# **FIRE SAFETY INSPECTION REPORT**

**Factory Name: AB APPARELS LTD**

**Date: 09 November 2016**

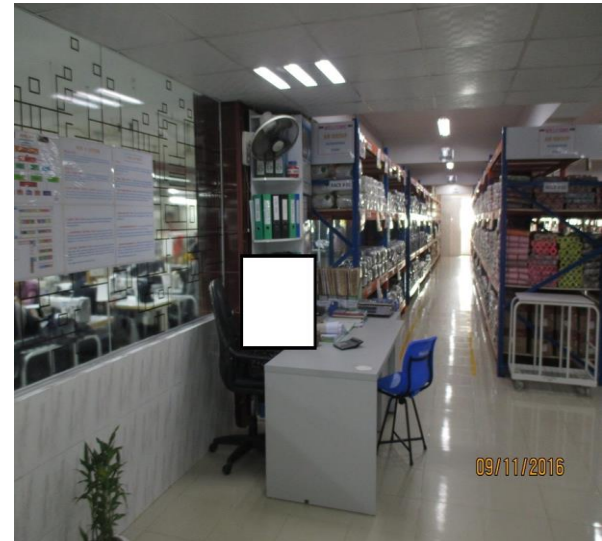
Rooms used for storage of combustible materials are not separated from the surrounding occupancy/areas/exit stair.

**Location: 2nd & 4th Floor**

Rooms used for storage of combustible materials shall be separated from the surrounding occupancy with a minimum 1 hour construction.

**\*\*If store rooms is directly connected to exit stair by fire rated doors, in that case fire doors shall be interfaced with fire alarm system**
